**PLANNING ACTION:** PA-T2-2022-00037

**SUBJECT PROPERTY:** 165 Water Street, 160 Helman Street and 95 Van Ness (*corner of Van Ness & Water Streets*)

**MEMO FOR FILE**  
**Magnolia Terrace Subdivision**

Modification and Additional Information for PA-T2-2022-0037: A request for an eight-lot commercial subdivision to construct a phased mixed-use development for the three properties at 95 Van Ness Street, 165 Water Street and 160 Helman Street. The applicant's Phase I requests Site Design Review approval for five mixed-use commercial buildings with ground floor commercial spaces and two residential units above in each building, as well as associated surface parking, utility infrastructure and street improvements. The three remaining building sites will be prepped for future construction.

# PRELIMINARY SUBDIVISION MAP

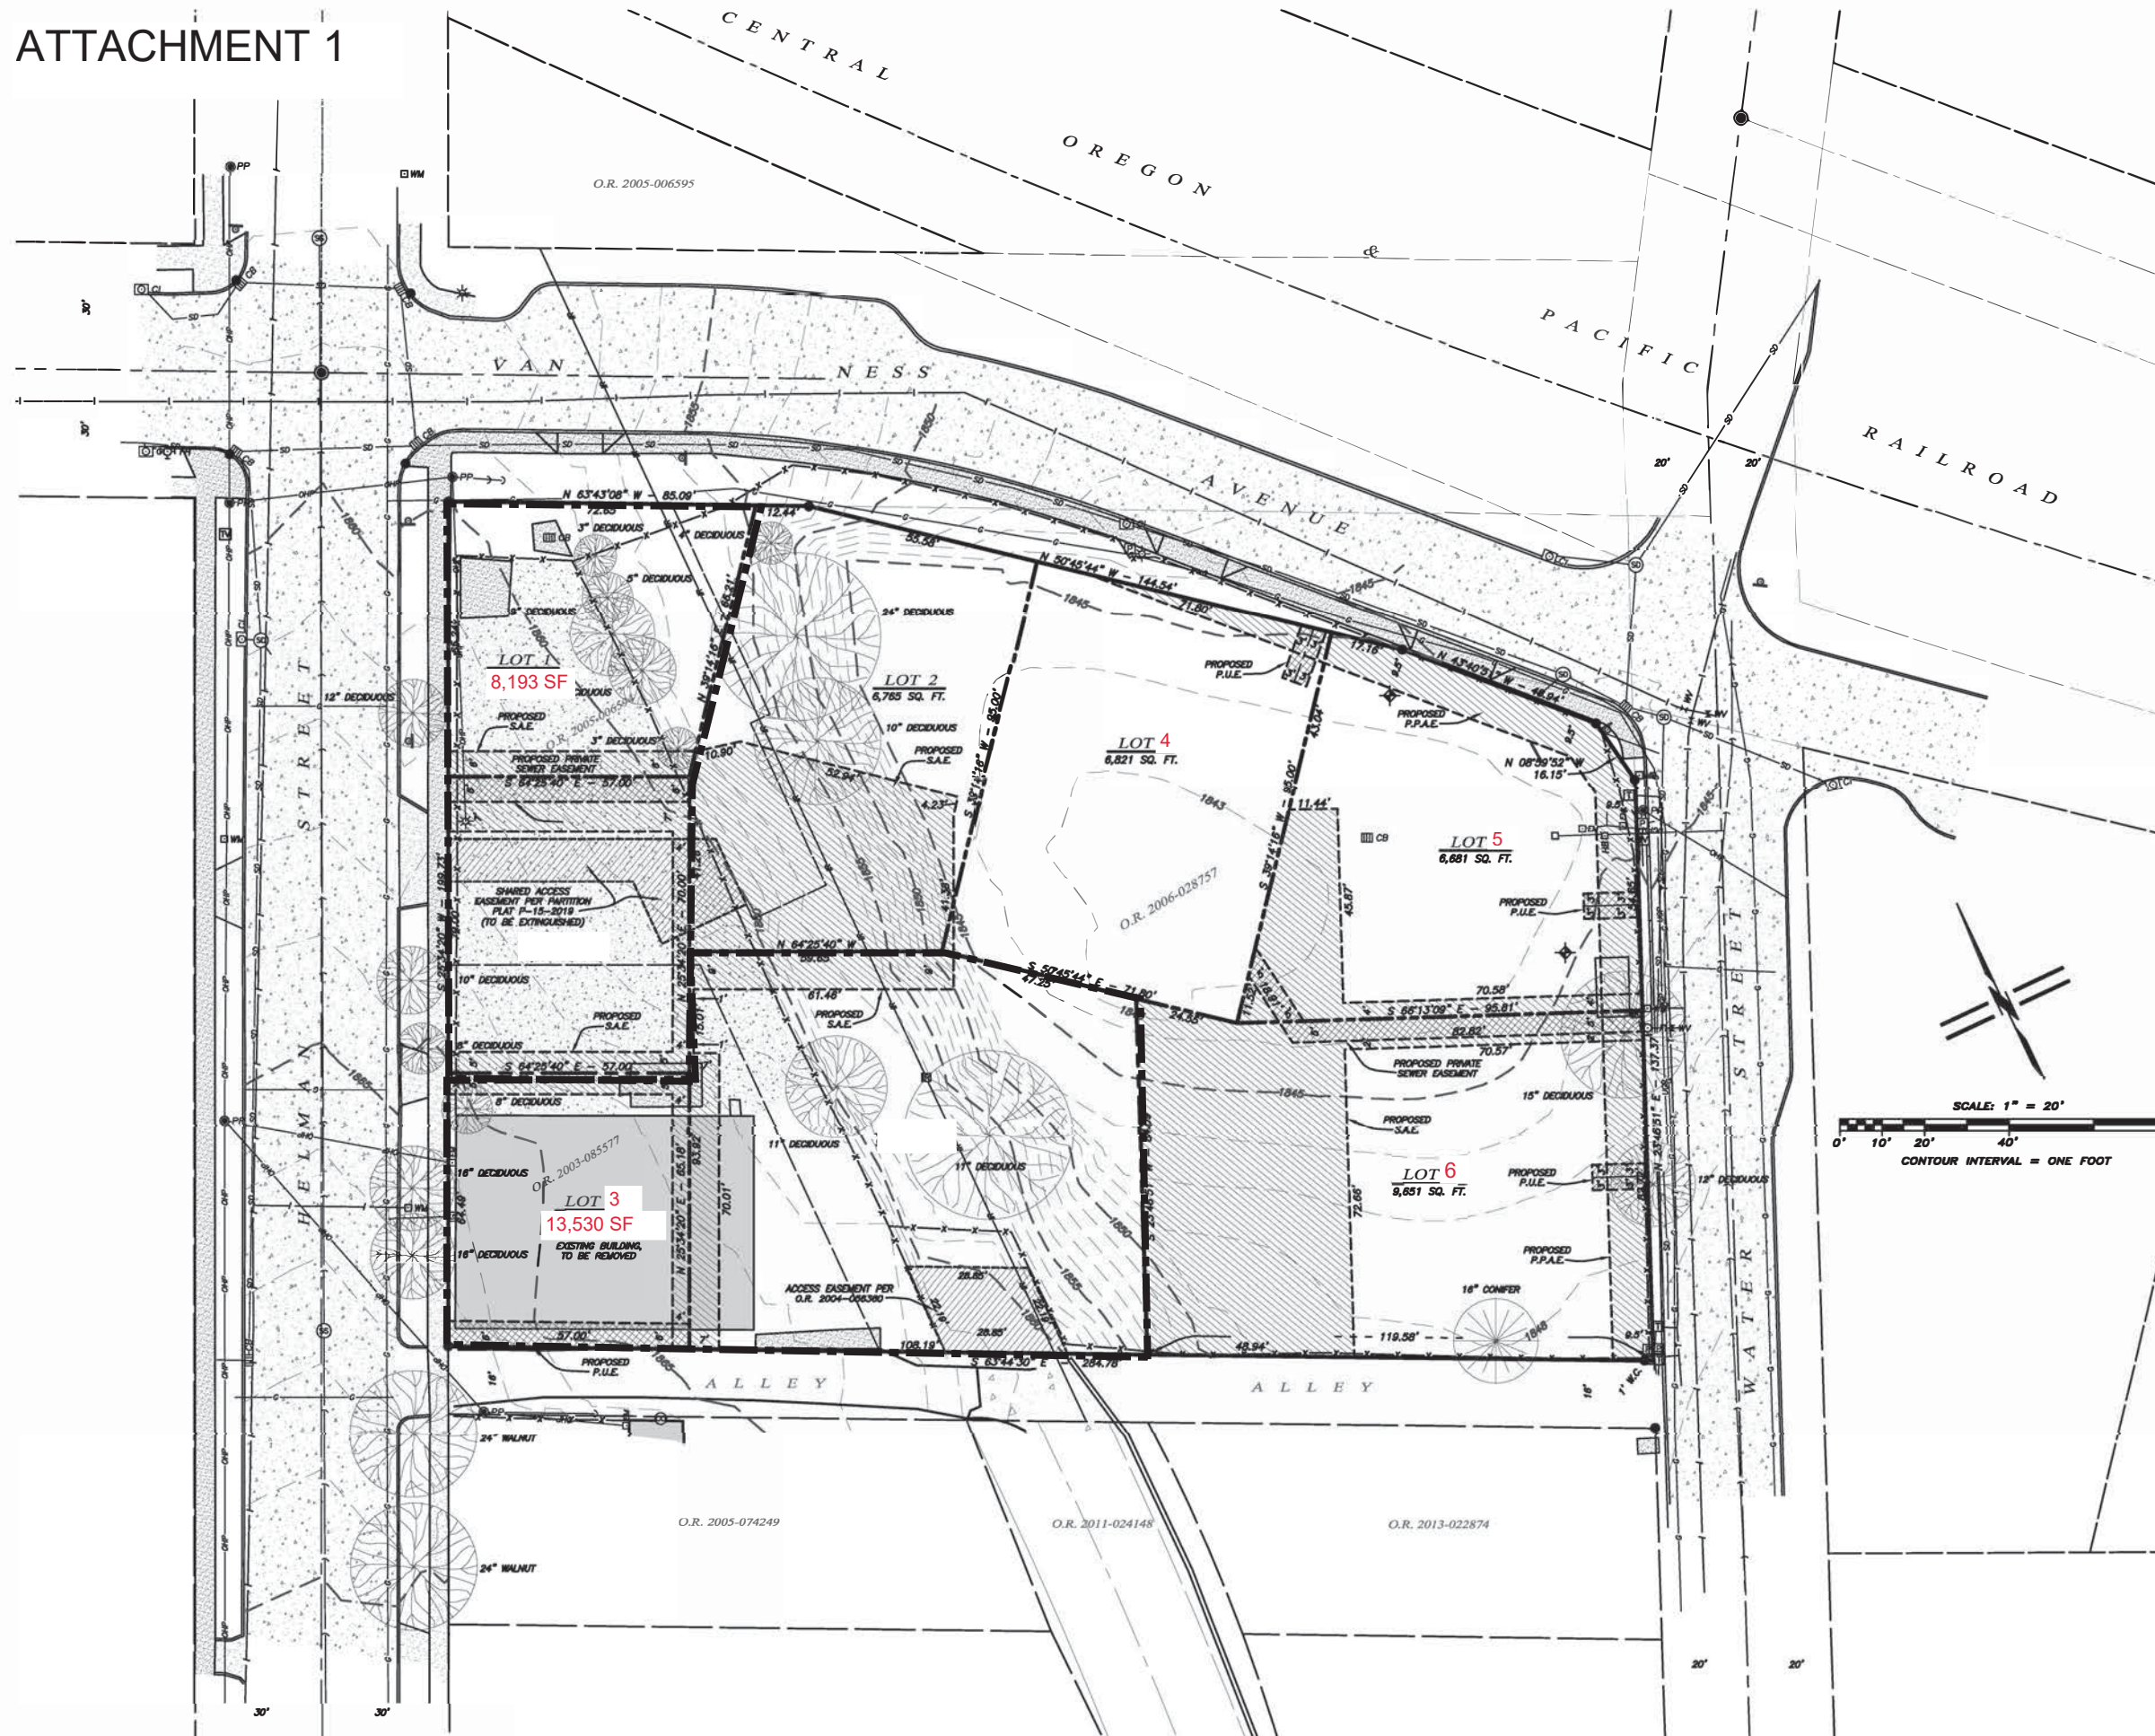
The proposal reduces the number of surface area tax lots proposed within the Magnolia Terrace Subdivision from eight (8) lots with eight condominium buildings, to six (6) lots with eight condominium lot buildings. The revised layout provides adequate street frontage for each lot in the subdivision. See Revised Preliminary Plat - Attachment 1.

PLANNING REVIEW  
 OPEN SPACE DIAGRAM  
 PHASE 1

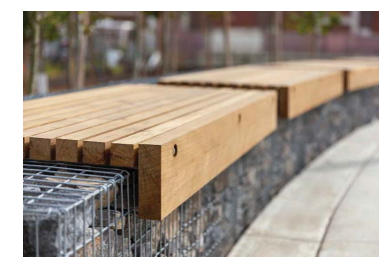
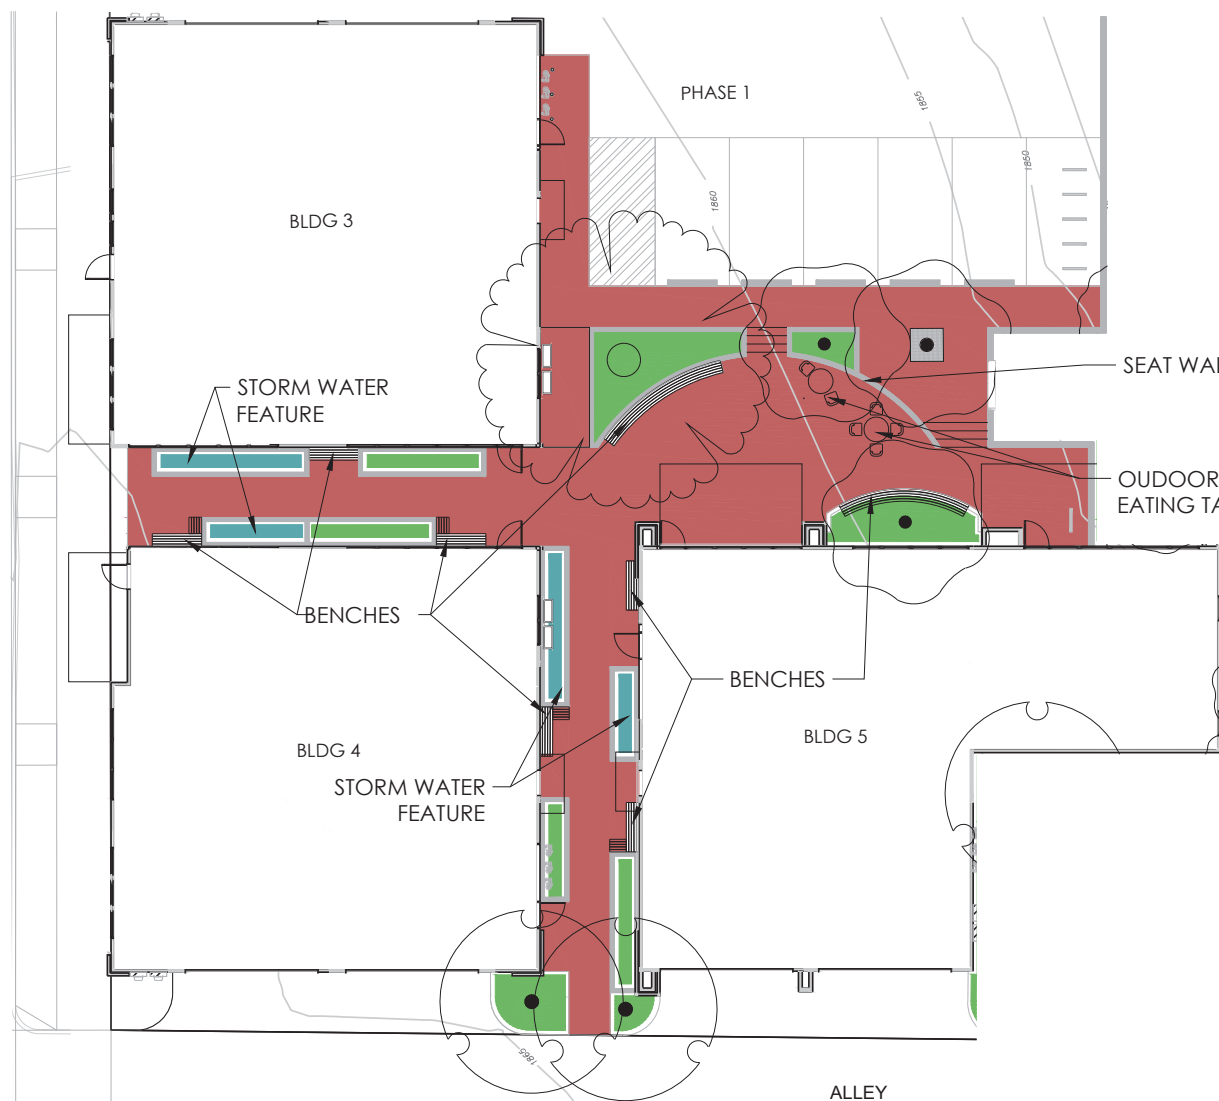
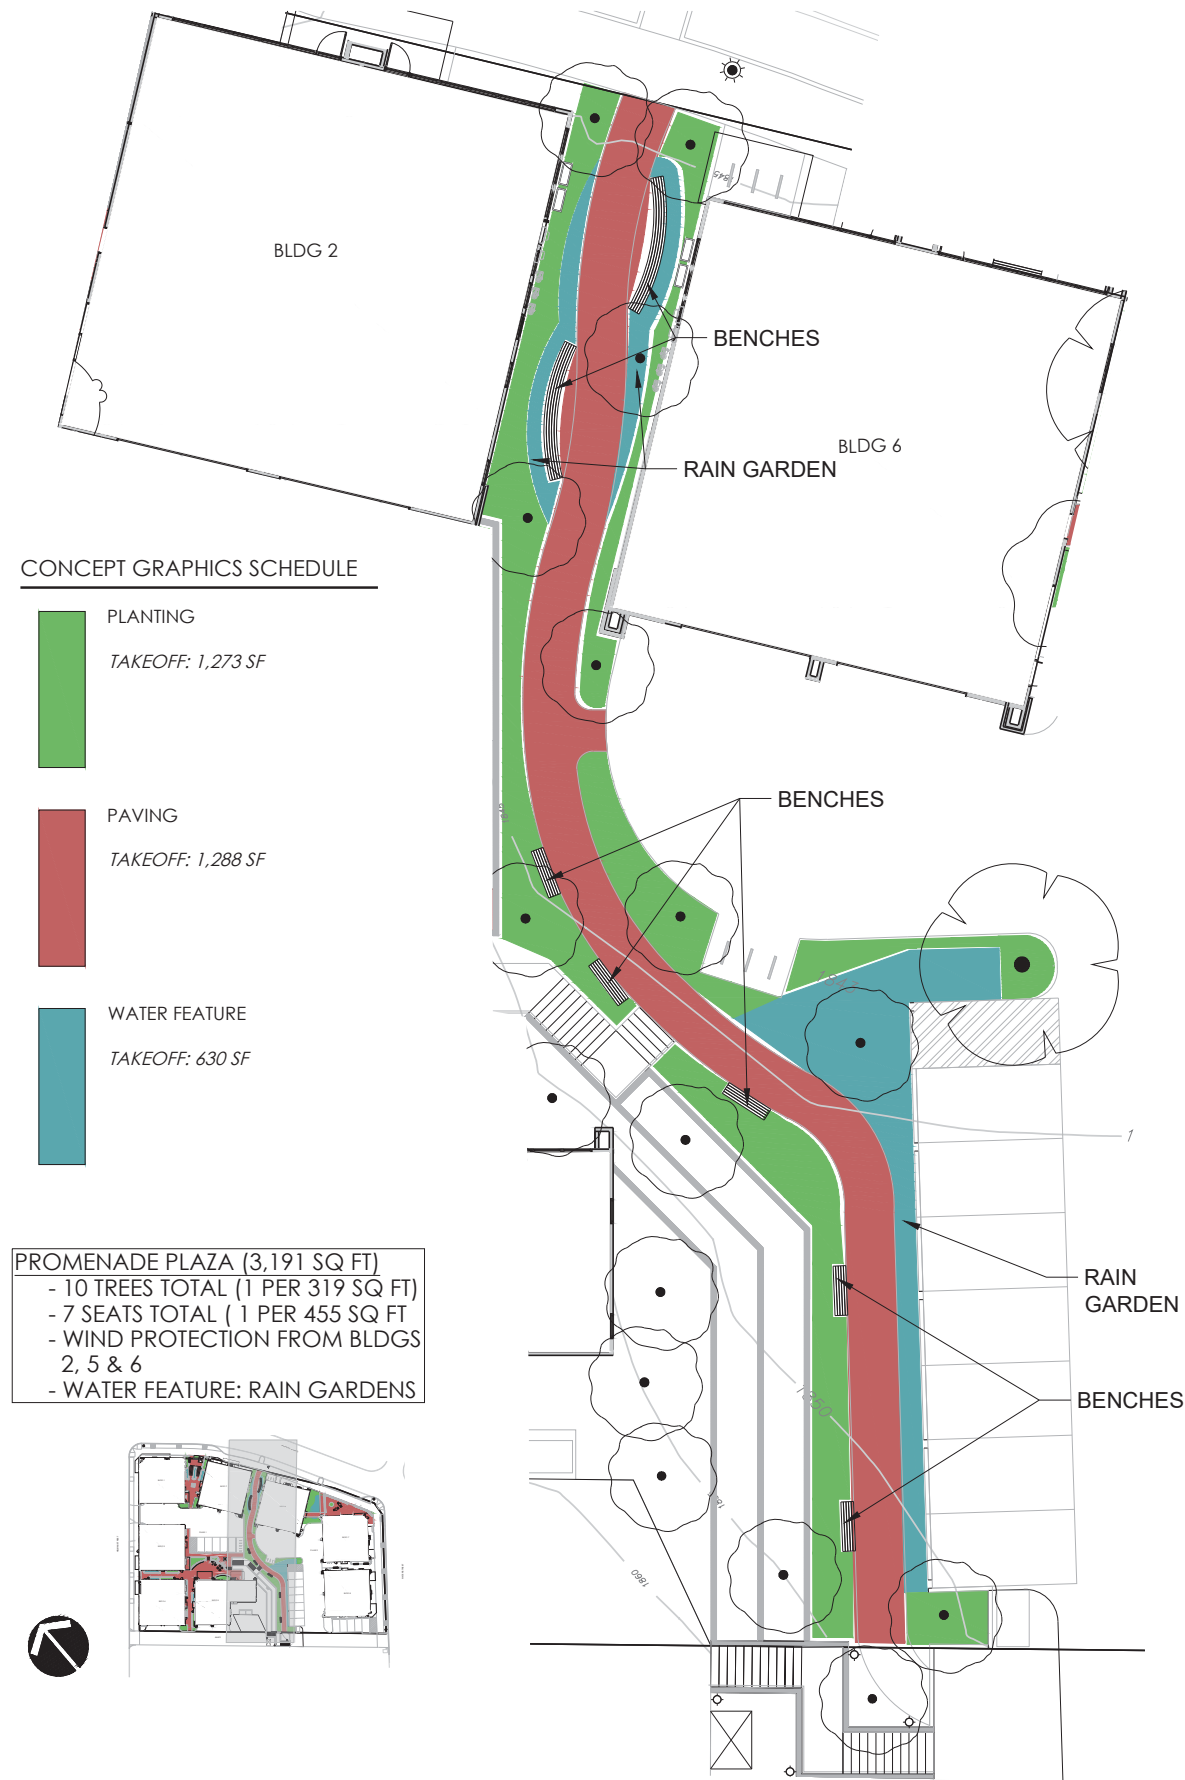
There are two plaza areas are proposed in Phase 1. Of the total 5,581 square feet of plaza area required, 3,451 square feet of plaza area is required for Phase 1. There is 4,083 square feet of plaza area proposed in Phase 1. The plaza areas are shown on Attachment 2 (Open space Diagram - L0.3)

Helman Plaza is 2,993 square feet in area to the south of the parking area. This plaza incorporates the pedestrian walkways between Buildings 3 and 4, and Buildings 5 and 6.

West Van Ness Plaza is 1,090 square feet in area and is the area between Buildings 1 and 2, providing pedestrian access from Van Ness to the parking area and through the development to the Helman Plaza.

PLANNING REVIEW  
 OPEN SPACE DIAGRAM  
 PHASE 2

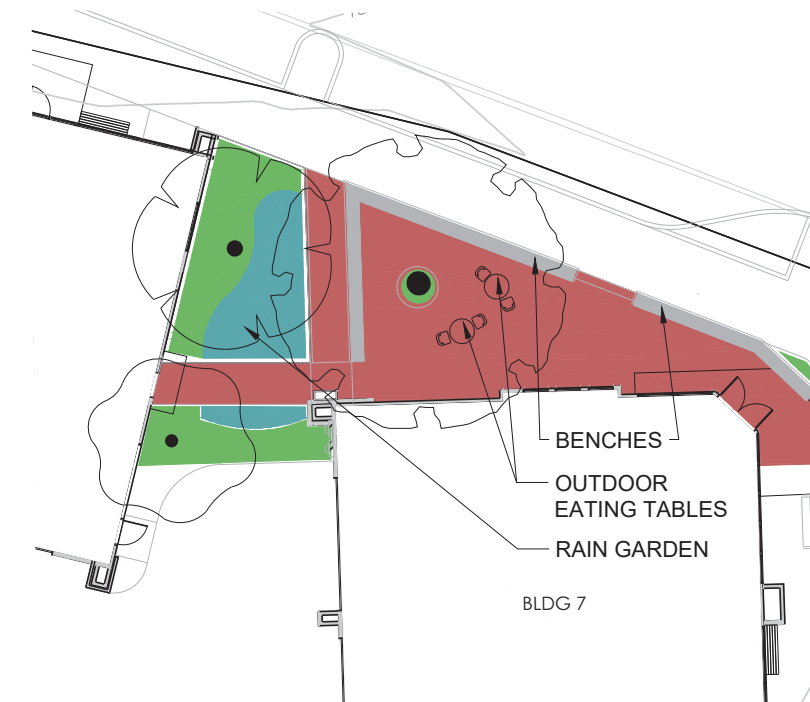
There are two additional plaza areas in Phase 2, see Attachment 3, sheet L0.4. These include the Promenade Plaza. This plaza area is at the base of the structural retaining walls and includes the walkway from Van Ness through to the alley along the south property line. The Promenade Plaza is 3,191 square feet in area. Has ten trees, seven seats, wind protection from the wall and the buildings. Raingardens are the proposed water features.

Attachment 4

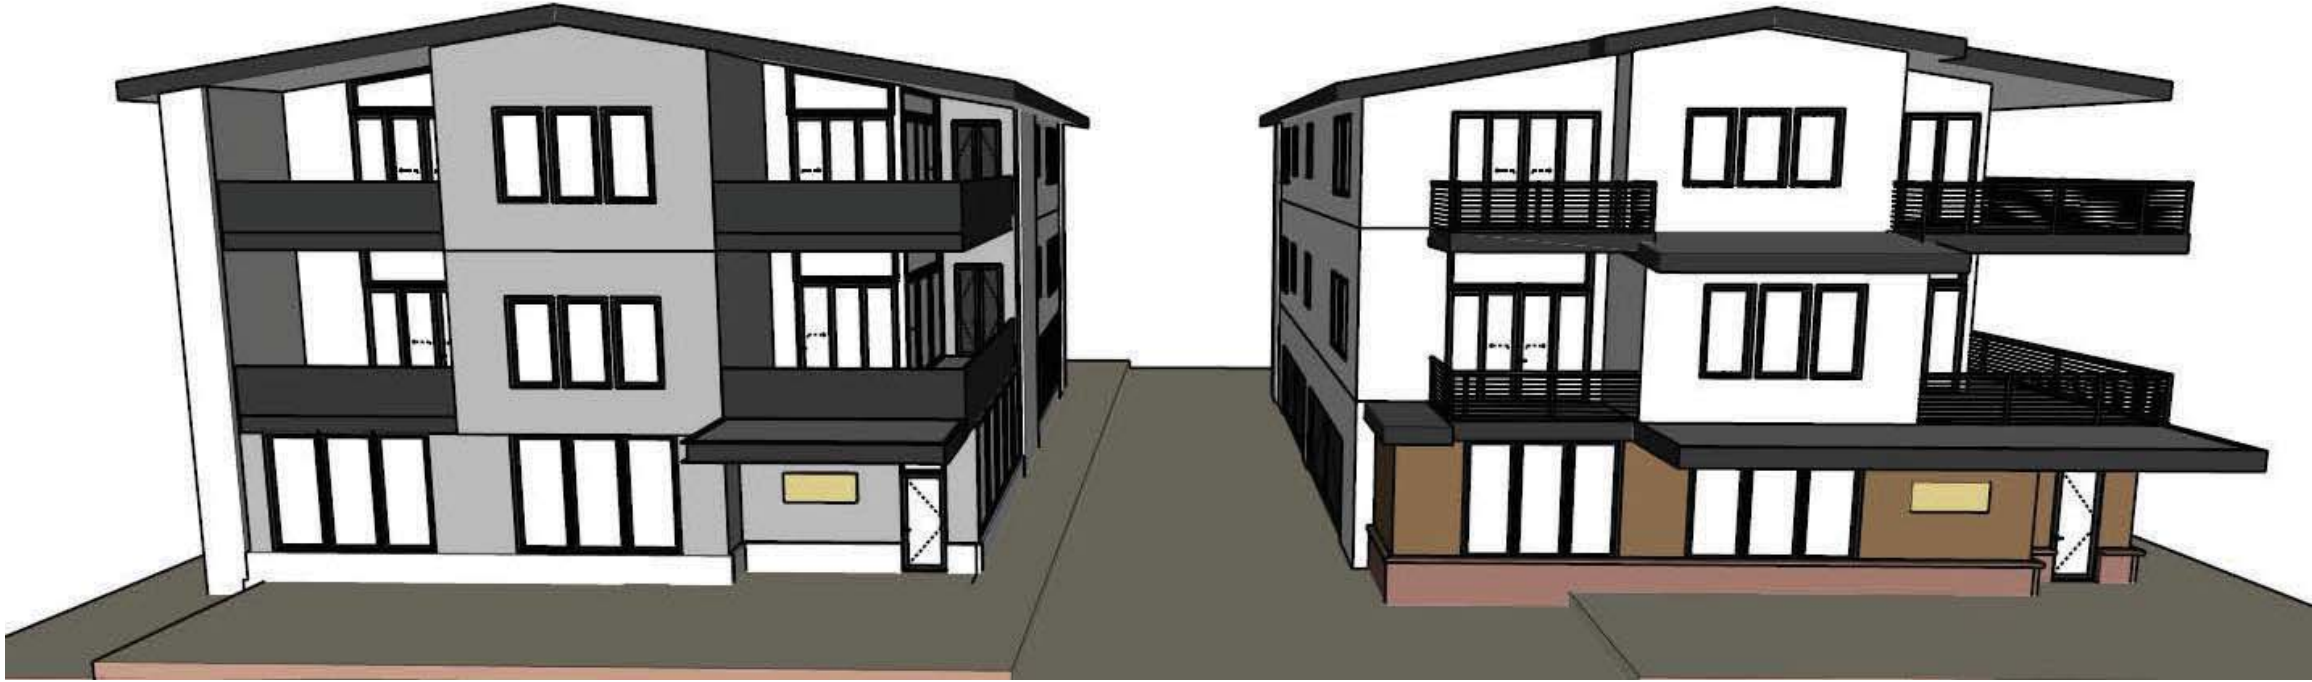
- The roofline has been cut back substantially to reduce the massing of the overhang.
- The center bay on buildings 3 and 4 steps back three feet for the third floor from the wall plane of the second floor and a shed roof has been added that emphasize the step back.
- Surface material changes to buildings 3 and 4.
- Added a brick base to provide a strong base that grounds the building.
- Pedestrian overhang on the ground floor was increased in length to add shadow lines and increase the pedestrian scale of the building when at the sidewalk.
- White and lighter materials used on the third story to fade the building away.
- Open wire or mesh railings instead of the previously proposed solid panel railings.

Attachments 4 provides a side-by-side comparison of the original massing of proposed Building 3 compared to the proposed modifications massing.
